### Office Action Summary

10/542,975

MARTIN, ALASTAIR J.

**DETAILED ACTION**

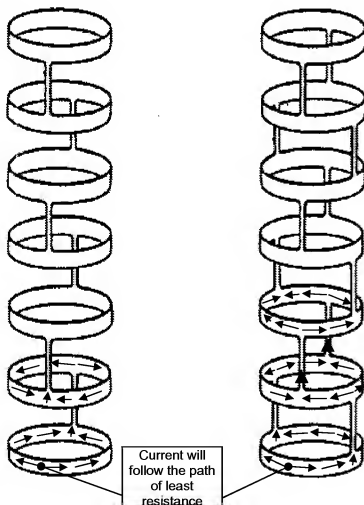
Regarding claim 12, Lau et al. disclose a stent for use in intravascular therapy, the stent comprising: a plurality of electrically conductive elements arranged in a generally tubular structure, the conductive elements comprising generally diagonally arranged struts with respect to a central axis of the stent (Figures 1-3), the conductive elements comprising: a plurality of loops 12 disposed about a central axis of the stent; and a plurality of linking members 13 for joining the loops such that the loops and linking members form a generally tubular structure around the central axis of the stent. Lau et al. fail to disclose a plurality of non-conductive connector nodes as claimed. Pacetti discloses non-conductive connector nodes which minimize current loops (paragraph 0038; improvements in MRI imaging have been made at and shortly after the time of Pacetti's invention - see attached Notice of References Cited) flowing within a stent in order to enable better MRI imaging (Abstract, paragraphs 0033, 0035 and 0038). One of ordinary skill in the art would have recognized the benefit of this modification to the Lau et al. stent because it is well-known in the art to use MRI imaging when deploying stents of similar function and structure to those of Lau et al. Therefore, it would have been obvious to one of ordinary skill in the art to have placed the nodes of Pacetti anywhere throughout the stents of Lau et al. in order to minimize current loops flowing

within the stent so that MRI imaging is enhanced. With this modification, the nodes would be disposed among the conductive elements and would direct (the nodes at least participate in directing the current along its normal path and would prevent shorts in their immediate vicinity) a current induced by RF signals in an examination region of a magnetic resonance apparatus to flow in the conductive elements such that adjacent segment currents cancel each other and a net current flowing in the stent is substantially minimized (see current flows [→] below; the currents within each loop would substantially cancel or minimize the currents in adjacent loops as evidenced by Applicant's disclosure):

The above combination would also result in the loops and linking members being connected (intra-connected or indirectly inter-connected) within the non-conductive connector nodes such that the current flowing through adjacent loops substantially cancel each other (as shown above). Regarding claim 16, when the undulations of the Lau et al. stent are offset as in Figure 11, they would form an overall diamond-shaped mesh pattern on the stent (when the stent is expanded) and each loop would have a zig-zag pattern. Regarding claim 19, in the Figure 8 embodiment of the Lau et al. stent each zig-zag loop is connected to each neighboring zig-zag loop only once. Regarding claim 9, Lau et al. disclose that the connectors 13 connect neighboring loops at approximately 90 degree intervals (four connectors, col. 5, line 60) and disclose that in other embodiments the connectors are evenly spaced (Figures 8-10). Therefore, it would have been obvious to one of ordinary skill in the art to have distributed the four connectors evenly which would result in 90 degree intervals as claimed. Furthermore regarding claims 19 and 20, as can be seen in the drawings above, the current would flow in opposite directions in adjacent loops no matter how many connectors are used so long as the connectors are radially offset between adjacent loops as disclosed by Lau et al. (col. 5, lines 42-48).
